BAR Meeting
March 4, 2009

ISSUE: Addition/Alterations
APPLICANT: Karl and Lydia Svoboda
LOCATION: 113 Princess Street
ZONE: RM/Residential

BAR CASE #2008-0158, 0159 3/4/2009

The applicant is requesting approval of a Certificate of Appropriateness for an addition and alterations at 113 Princess Street.

Figure 5. Proposed rear (north) elevation.

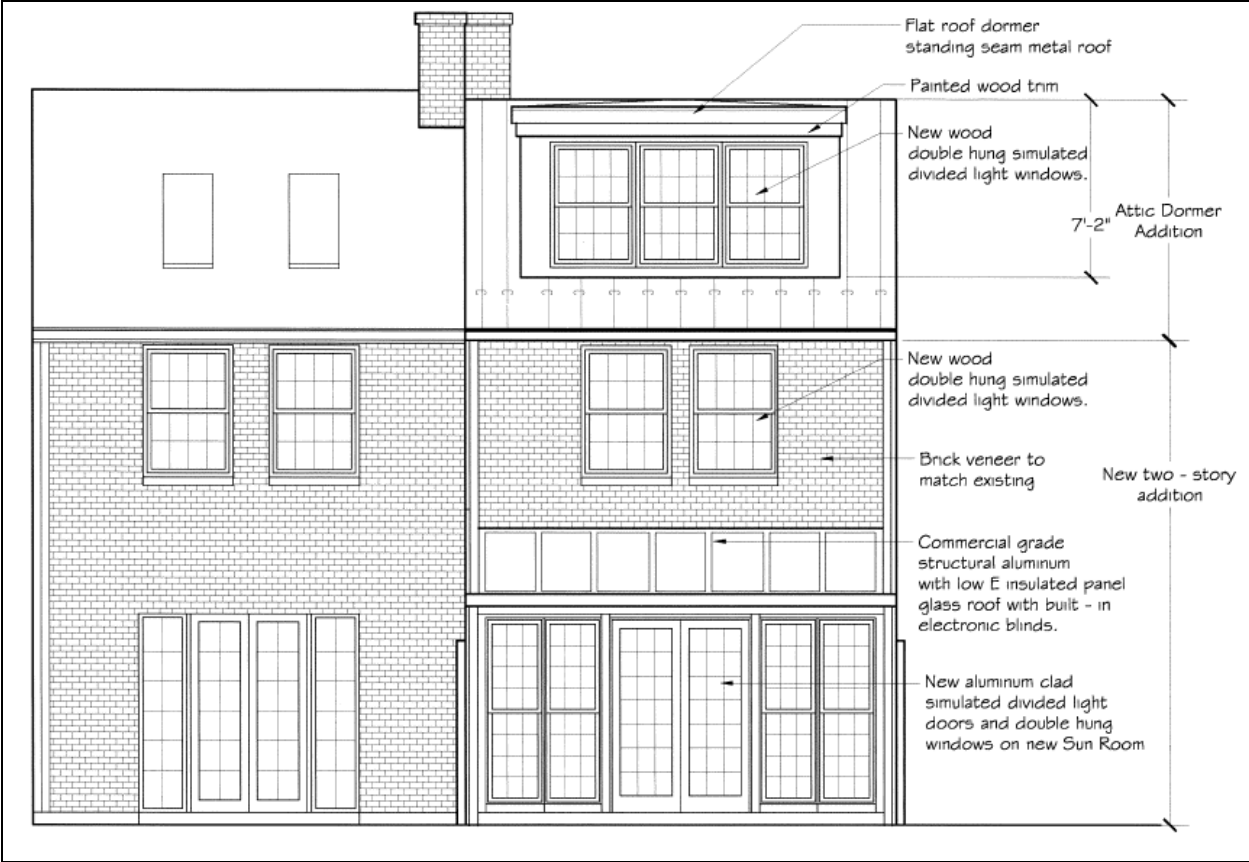
The applicant proposes to construct a two-story with basement addition measuring approximately 14' by 18' at the first story and 6' by 18' at the second story on the rear (north) elevation of the existing house. The existing house currently measures approximately 37' by 18'. Originally, the depth of the addition was proposed to be 16.5' but was reduced to 12' in the second revision. Also, the two previous proposals featured a one-story addition with an elevator shaft at the second story. The addition will be a sun room and will have double multi-light doors flanked by pairs of twelve-over-twelve, double-hung windows on the north elevation. The doors and windows are proposed to be aluminum clad and simulated divided light. The applicant proposes a glass shed roof on the first floor addition. The glass roof will have commercial grade structural aluminum with low-E insulated panel glass. The side elevations (east and west) will be all brick to match the existing house. The second-story of the addition is proposed to be smaller, extending 6' from the existing rear wall. The second story will have a pair of eight-over-eight, simulated divided light, double-hung wood windows. The exterior will be clad in a brick veneer to match the existing.

On the roof of the rear (north) elevation the applicant proposes a shed dormer. The dormer addition will extend approximately 13.5'. The dormer will have three eight-over-eight, double-hung, simulated divided light, wood windows. The shed dormer will have a standing seam metal

The applicant proposes to replace all the existing windows with simulated divided light wood windows, to match the existing light patterns, with the exception of the windows on the addition which are proposed to be aluminum clad rather than all wood.

The *Design Guidelines* recommend that: “...replacement windows should be appropriate to the historic period of the architectural style of the building.” In this particular case, given the age of the townhouse and the fact that the existing six-over-six light configuration and 7/8” muntin profile will be retained, Staff does not object to the installation of double-insulated replacement windows with simulated divided lights and spacer bars. However, Staff recommends that all the replacement windows and doors be all wood.

1. That the applicant install nightshades on the glass roof of the rear addition to control light spillage;
2. That all the proposed simulated divided light windows have exterior-applied muntins with interior spacer bars and match the muntin width of the existing windows;

3. That the windows and doors be all wood and not aluminum clad; and,
4. The statements in archaeology conditions below shall appear in the General Notes of all site plans and on all site plan sheets that involve demolition or ground disturbance (including Basement/Foundation Plans, Demolition, Erosion and Sediment Control, Grading, Landscaping, Utilities, and Sheeting and Shoring) so that on-site contractors are aware of the requirements:
